NEBRASKA ARMY NATIONAL GUARD
Wahoo Readiness Center Addition

PROJECT NO. 31030344

A D D E N D U M N O . 1

C3.0

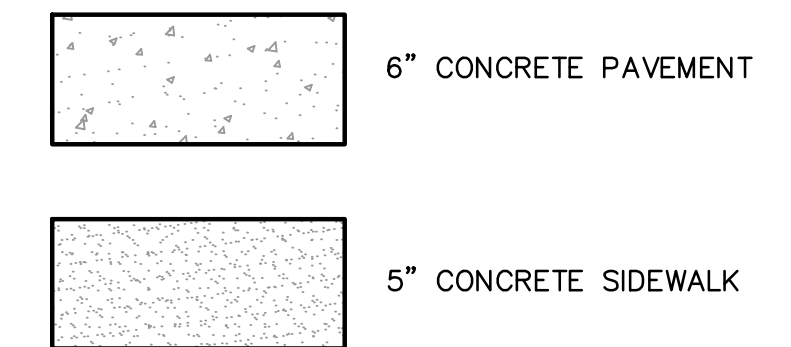
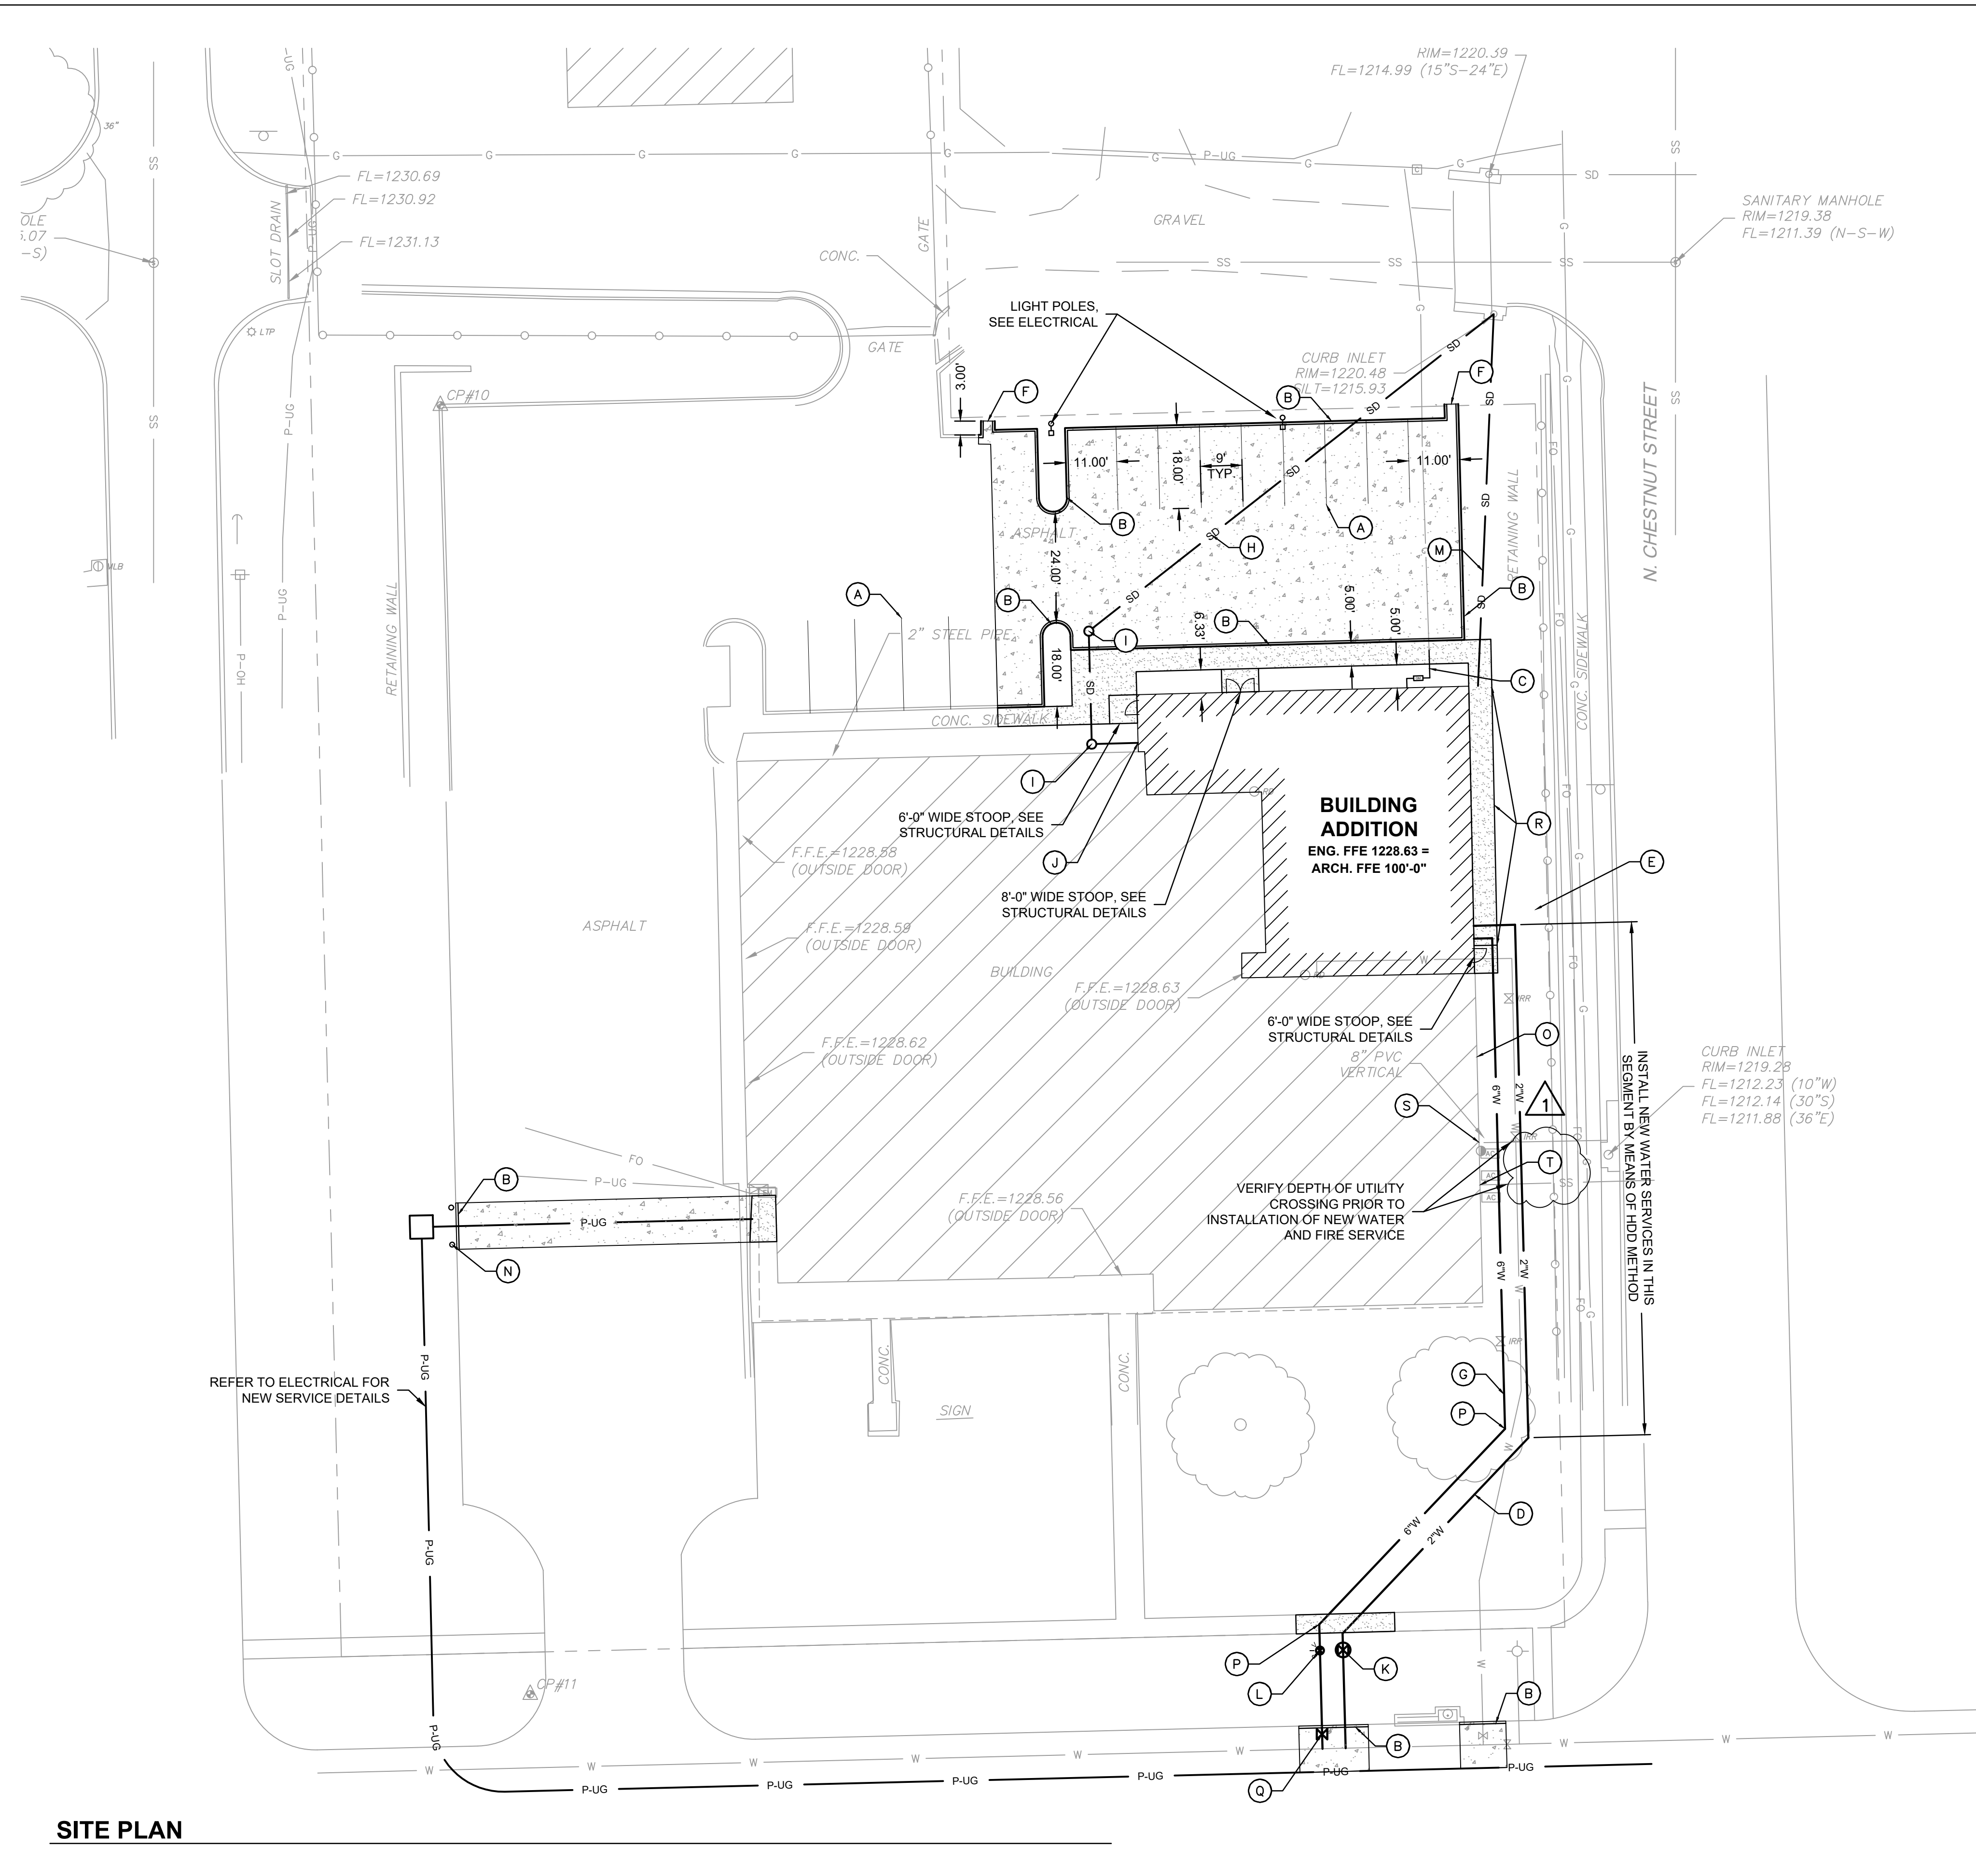
- 3. Sheet C3.0 SITE PLAN
 - a. Replace Sheet C3.0 with attached sheet
 - b. Added clarification to general note 1
 - c. Added site key note "T"
- 4. Sheet 5.0 STORM SEWER PLAN AND PROFILE

(T)	RECONNECT PROPOSED SANITARY SEWER TO EXISTING SANITARY SEWER, SEE MECHANICAL SHEET M1.0

FLOOR TYPE FL-1: TYPICAL SLAB ON GRADE

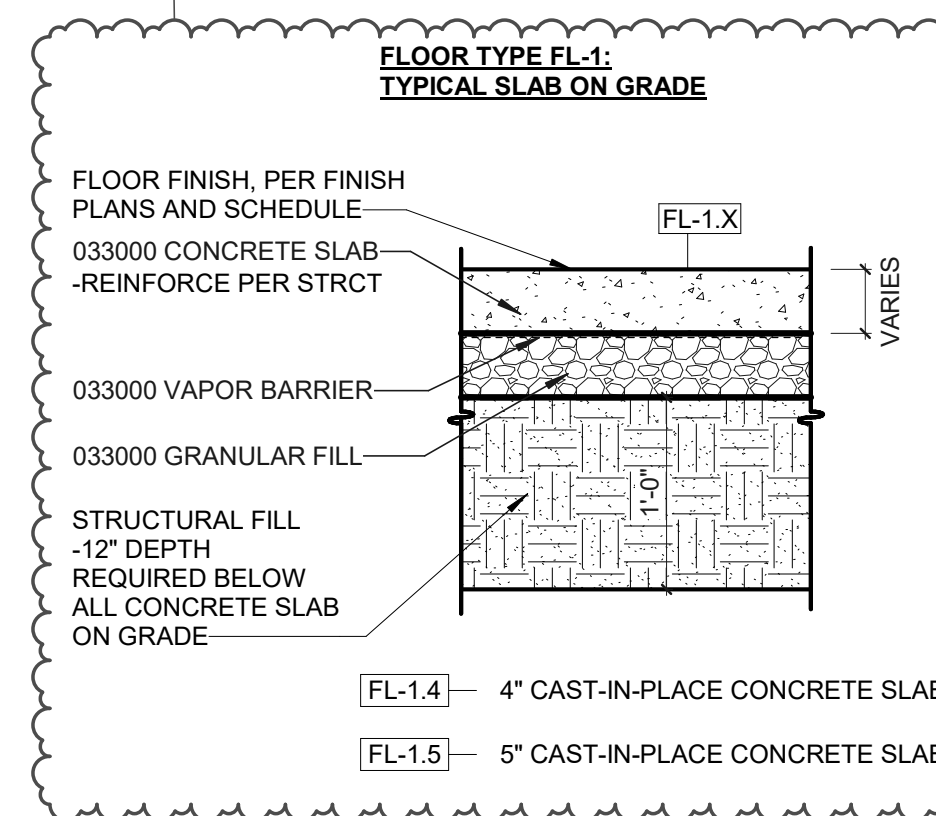
- a. Rotate north arrow 90 degrees to the left
- 5. Sheet A0.1 WALL, FLOOR AND ROOF TYPES
 - a. Floor Type FL-1 has been updated to show 12" of structural fill below all slab on grade concrete floors.

1 FIRST FLOOR PLAN

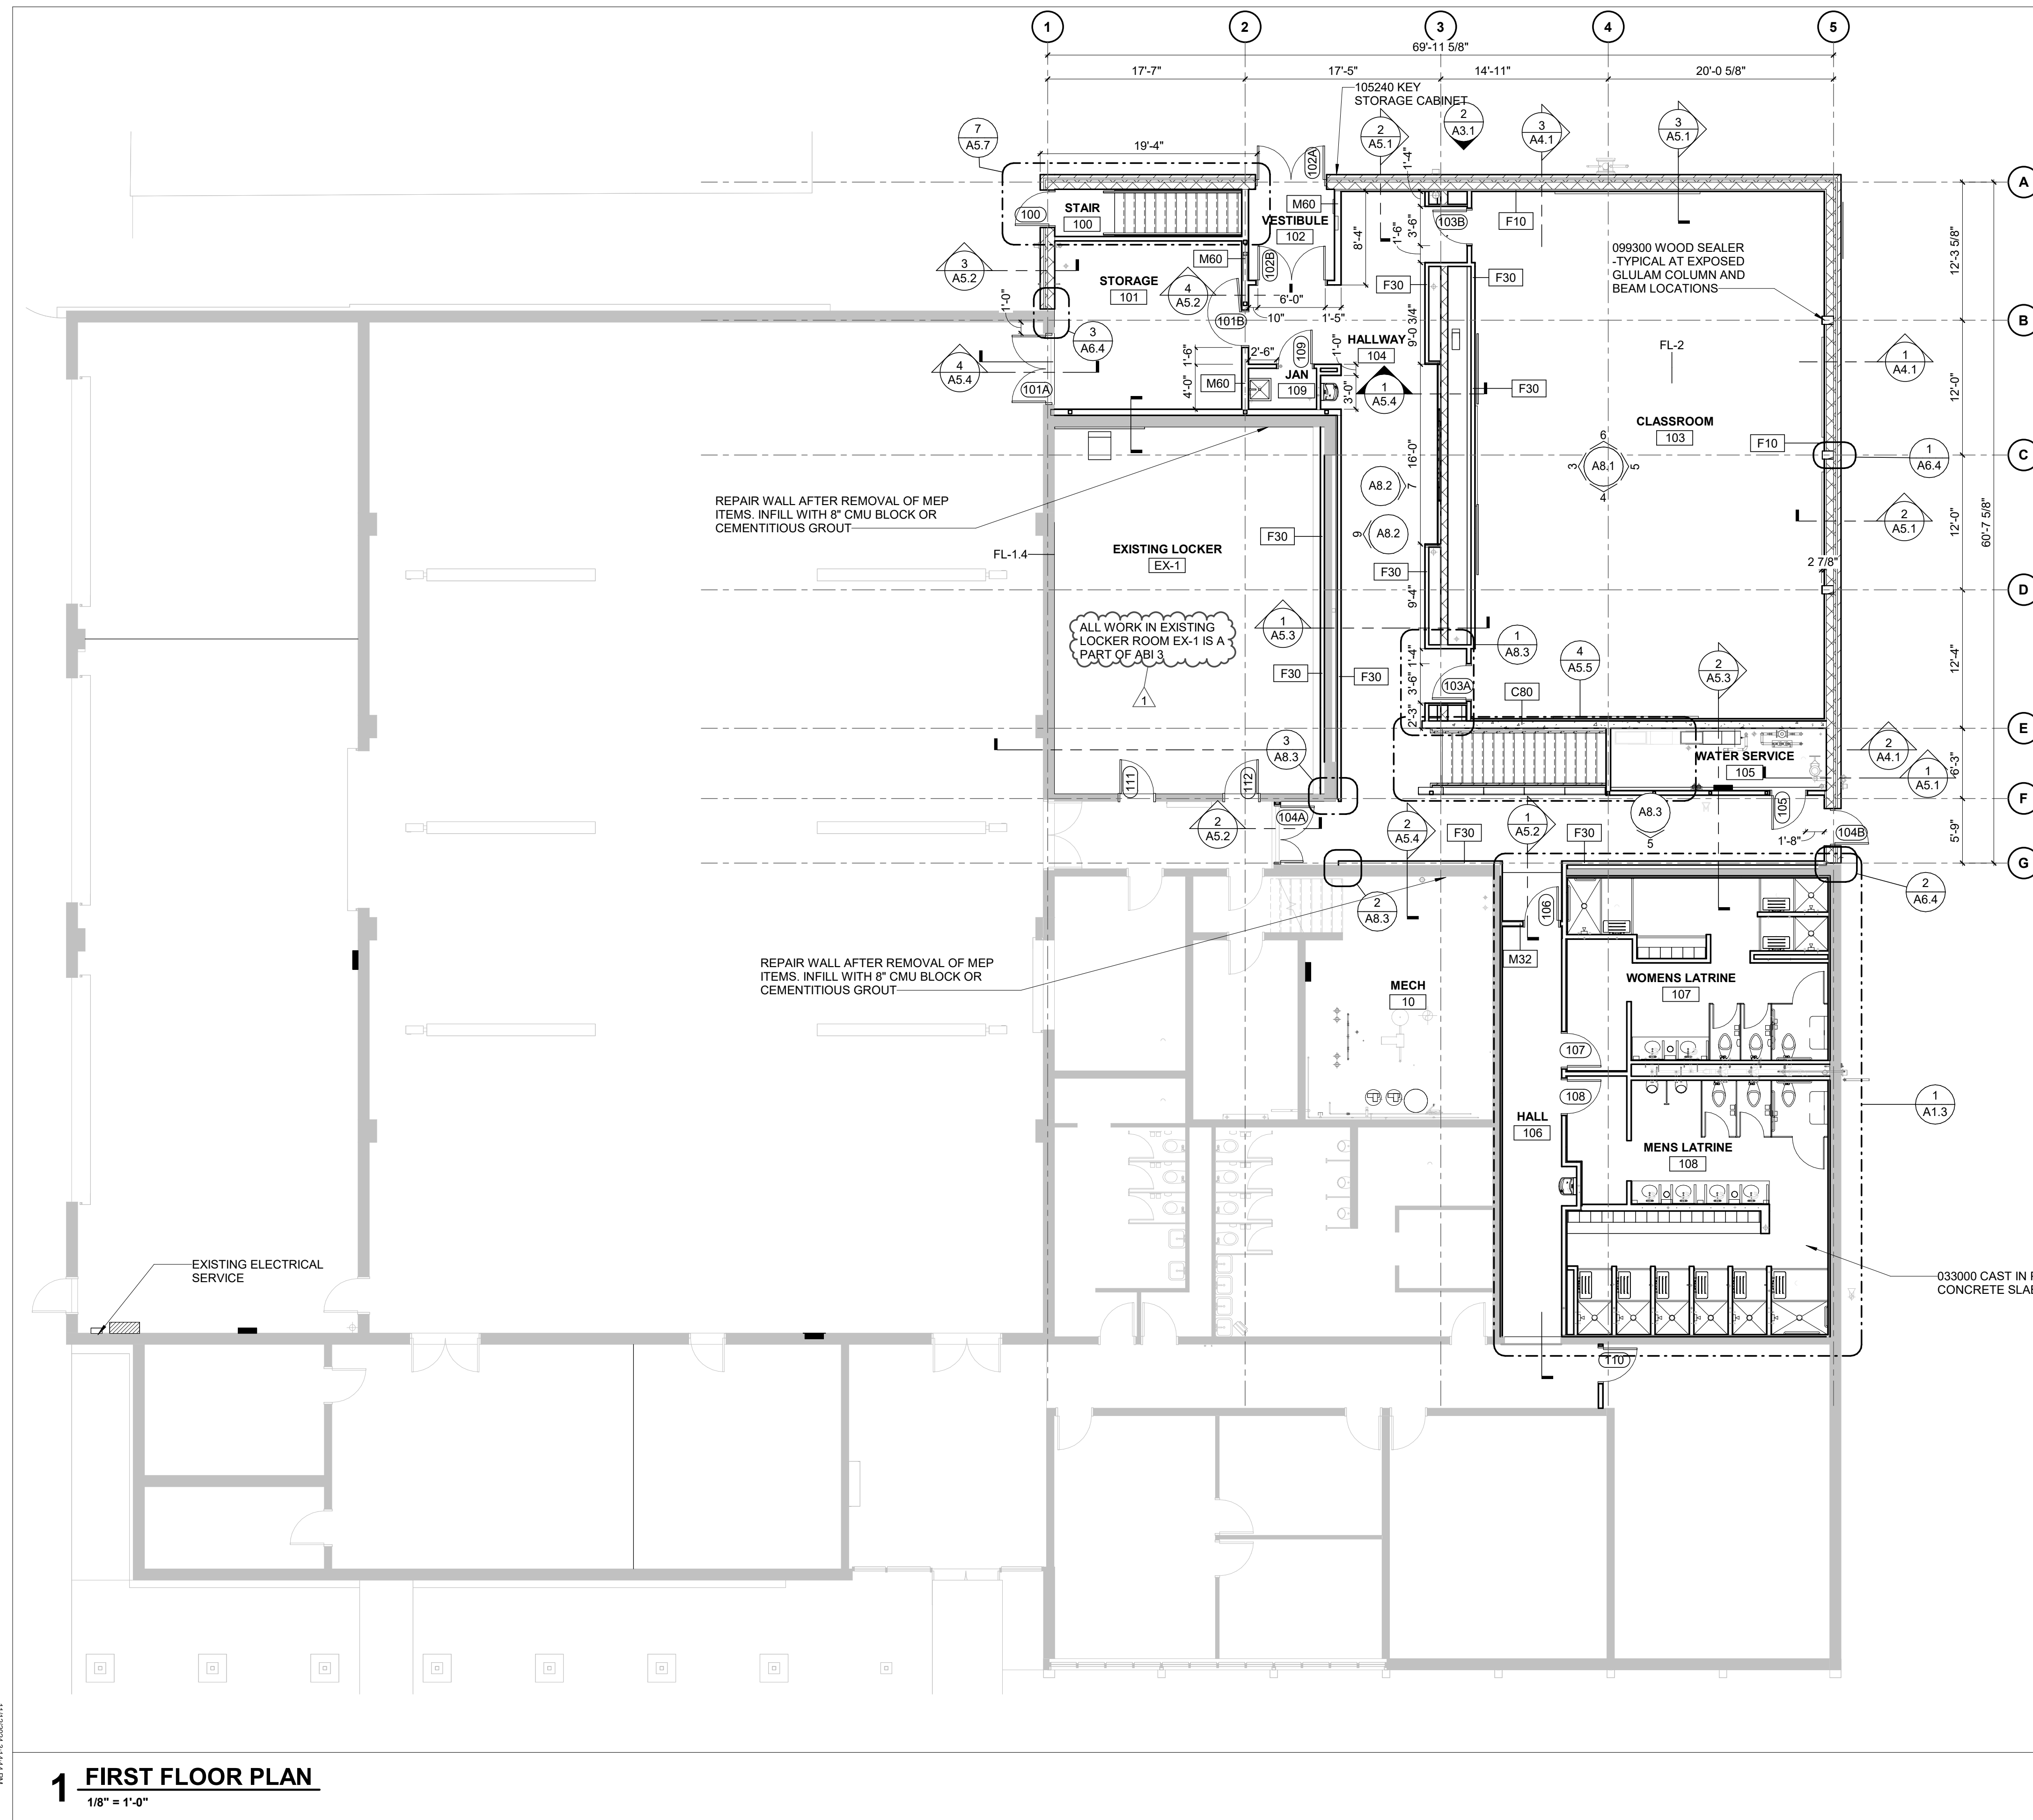
- 6. Sheet A1.1 FIRST FLOOR PLAN
 - a. FIRST FLOOR PLAN: Alternate bid item number corrected.
- 7. Sheet A8.2 INTERIOR ELEVATIONS & DETAILS
 - a. Detail 7: Alternate bid item number corrected.
